TURKEY POINT NUCLEAR GENERATING STATION UNIT 3 AND UNIT 4

IMPROVED TECHNICAL SPECIFICATIONS CONVERSION

ITS SECTION 3.1 REACTIVITY CONTROL SYSTEMS

Revision 2

Figure B 3.1.6 (page 1 of 1)
Control Bank Insertion vs. Percent RTP

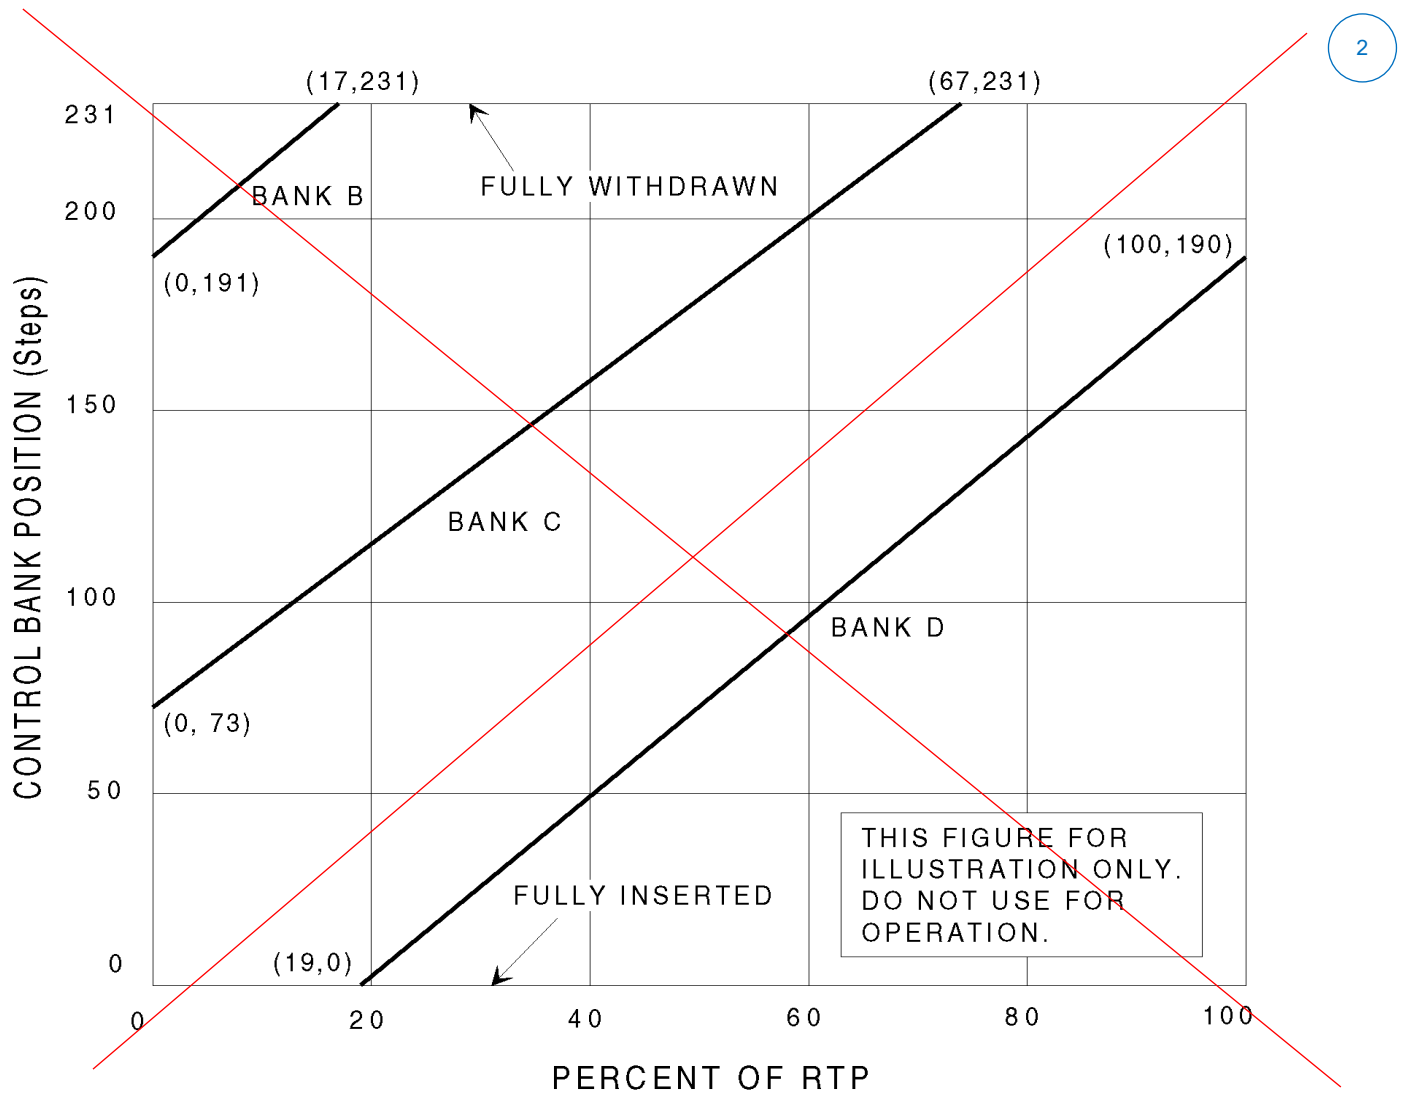
2. ISTS 3.1.6 contains Figure B 3.1.6-1 and states that it is an example provided for information only. Turkey Point Nuclear Generating Station (PTN) Improved Technical Specification (ITS) 3.1.6 does not include Figure B 3.1.6-1. The control bank insertion limits for PTN are located in the Core Operating Limits Report (COLR). Therefore, ISTS Figure B 3.1.6-1 and the references to the ISTS Figure B 3.1.6-1 have been deleted.

Figure 3.1-2
BORIC ACID TANK MINIMUM VOLUME (1)
Modes 1, 2, 3 and 4

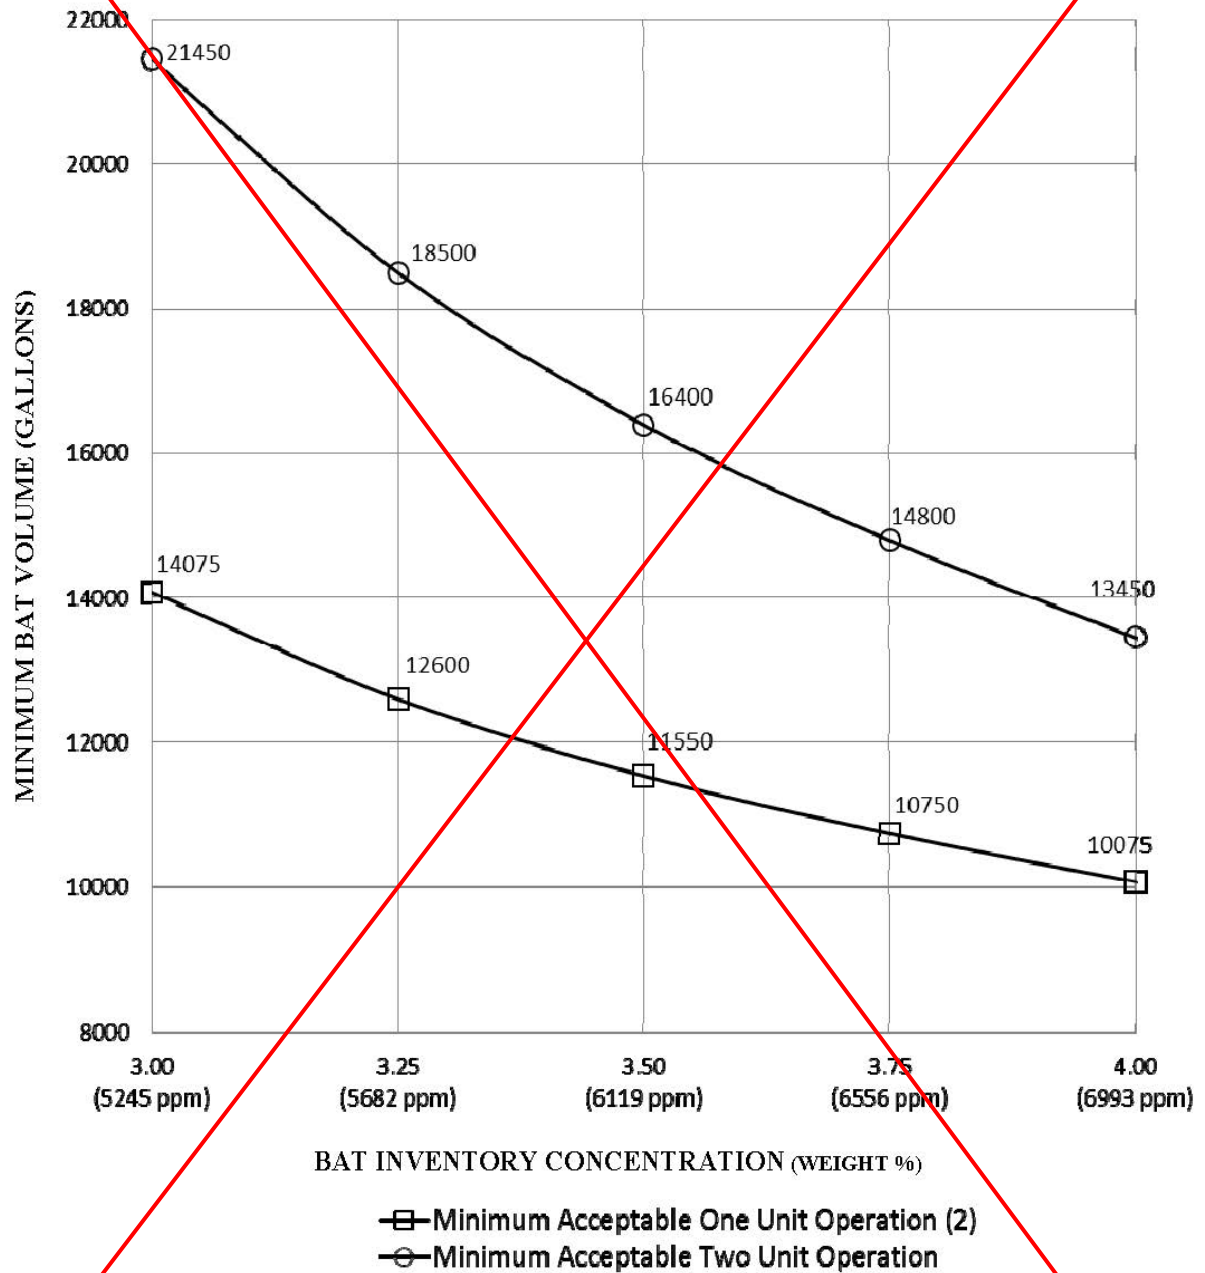
- a. ~~— A Boric Acid Storage System with:~~
 - 1) ~~— A minimum indicated borated water volume in accordance with Figure 3.1-2,~~
 - 2) ~~— A boron concentration in accordance with Figure 3.1-2, and~~
 - 3) ~~— A minimum boric acid tanks room temperature of 62°F.~~
- b. ~~— The refueling water storage tank (RWST) with:~~
 - 1) ~~— A minimum indicated borated water volume of 320,000 gallons,~~
 - 2) ~~— A boron concentration between 2400 ppm and 2600 ppm.~~
 - 3) ~~— A minimum solution temperature of 39°F, and~~
 - 4) ~~— A maximum solution temperature of 100°F.~~

- a. ~~— With the required Boric Acid Storage System inoperable verify that the RWST is OPERABLE; restore the system to OPERABLE status within 70 hours or be in at least HOT STANDBY within the next 8 hours* and borated to a boron concentration equivalent to at least the required SHUTDOWN MARGIN at COLD SHUTDOWN at 200°F; restore the Boric Acid Storage System to OPERABLE status within the next 72 hours or be in COLD SHUTDOWN within the next 30 hours.~~
- b. ~~— With the RWST inoperable, restore the tank to OPERABLE status within 1 hour or be in at least HOT STANDBY within the next 6 hours and in COLD SHUTDOWN within the following 30 hours.~~
- c. ~~— With the boric acid tank inventory concentration greater than 4.0 wt%, verify that the boric acid solution temperature for boration sources and flow paths is greater than the solubility limit for the concentration.~~
